Commissioner Julia Levin, Presiding Member
Vice Chair James D. Boyd, Associate Member
Mr. Craig Hoffman, Project Manager
Abengoa Mojave Solar Project (09-AFC-5)
California Energy commission
1516 Ninth Street
Sacramento, CA 95814

**Re: Abengoa Mojave Solar Project (09-AFC-5): Written Response to Data
Request Set 1 (nos. 1-93)**

Figure 1. Supplemental Noise Analyses Locations along the Edge of the Dry Lake Bed

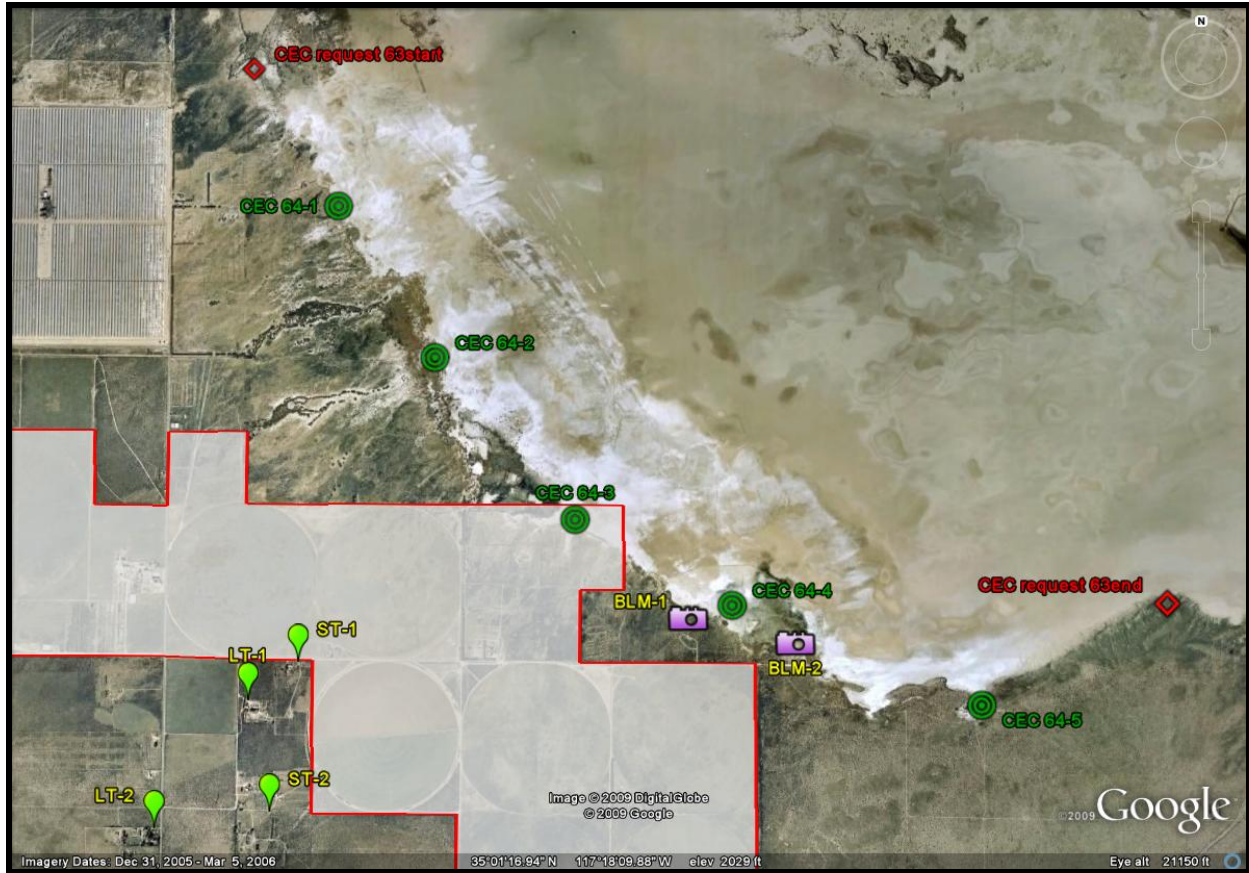
- A. Please provide estimated worst-case construction and operation noise levels (in dBA) along the southern shoreline of Harper Dry Lake between 35°02'22.35" N/ 117°19'31.63" W and 35°00'48.36" N/ 117°16'14.20" W. The data set should include estimated worst-case construction and operation noise levels at the Harper Dry Lake marsh habitat, northeast of the proposed Beta site.
- B. Provide a map of noise contours extending from the project noise source to Harper Dry Lake marsh and into the Harper Dry Lake bed.

A. The request for additional noise measurement data for ambient conditions and modeled construction and operational noise levels suggests that the CEC is trying to analyze potential adverse effects based upon exceeding a threshold value. Although a noise threshold has been established by some regulatory agencies for certain breeding or nesting avian species (e.g., the federally listed endangered least Bell's vireo), there are no currently adopted LORS that apply noise thresholds to non-threatened or endangered species. Since no threatened or endangered avian species have been documented as nesting on or adjacent to the project area, the applicant feels that this additional analysis is unwarranted. Additionally, the modeled construction and operational noise levels do not exceed 60 dBA at the outer edge of the migratory bird habitat associated with Harper Dry Lake (Table DR 1A-64a and Table DR 1A-64b), and in the vast majority of the cases, the predicted construction and operational noise levels are well below 60 dBA, and would not constitute an adverse effect even if threatened or endangered avian species were nesting or breeding on Harper Dry Lake.

Notwithstanding the above, please refer to the Figure 1 below for a depiction of supplemental noise analyses locations along the edge of the dry lake bed (and the marsh area). Please also refer to the Table 5 below which provides construction noise results at selected, representative locations along the edge of the dry lake bed. This supplemental table is an extension of and in the same format as the AFC Table 5.8-9.
